CITY OF ALBUQUERQUE
BELL/COMMERCIAL STORM WATER
PUMP STATION NO. 37 FORCE MAIN
DESIGN ANALYSIS REPORT

City of Albuquerque Bell/Commercial Storm Water Pump Station No. 37 Force Main

Purpose of Meeting: To discuss the review comments that the City had on the draft Design Analysis Report (DAR) that was submitted on Wednesday, November 24, 2010.

Junction Box Plan and Section

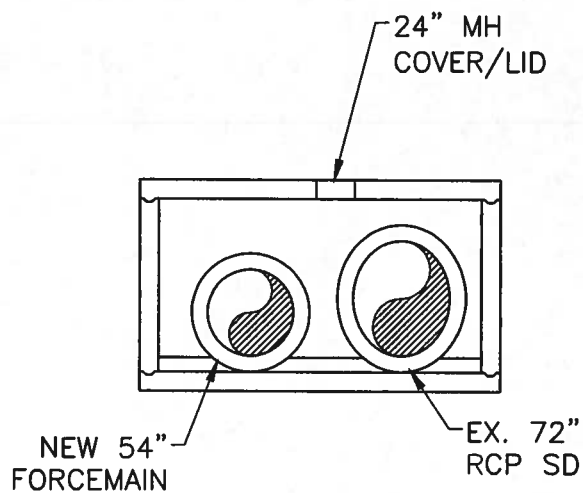
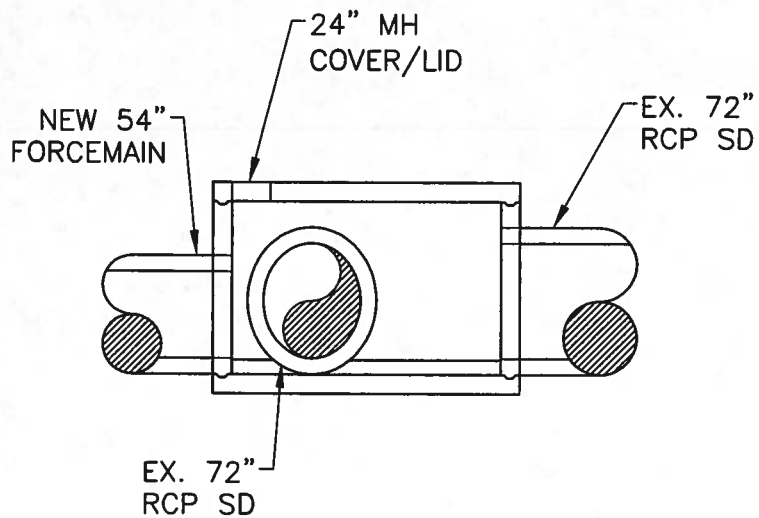
14. Question: How was the junction box modeled? As a pressure manhole or with free discharge of the force main? It was assumed to be a free discharge. Molzen Corbin will investigate this.

18. Question: What utilities were contacted and which have submitted responses? As indicated in the draft DAR, the following utilities were contacted: New Mexico Gas Company, PNM, QWEST, TW Telecom of NM, and Comcast. QWEST (local) responded and there are no conflicts. (NOTE: After the meeting, I contacted QWEST (long distance) and they indicated there are no conflicts.) No other utilities have responded.
19. Add a cross section view of the proposed junction box at Trumbull.
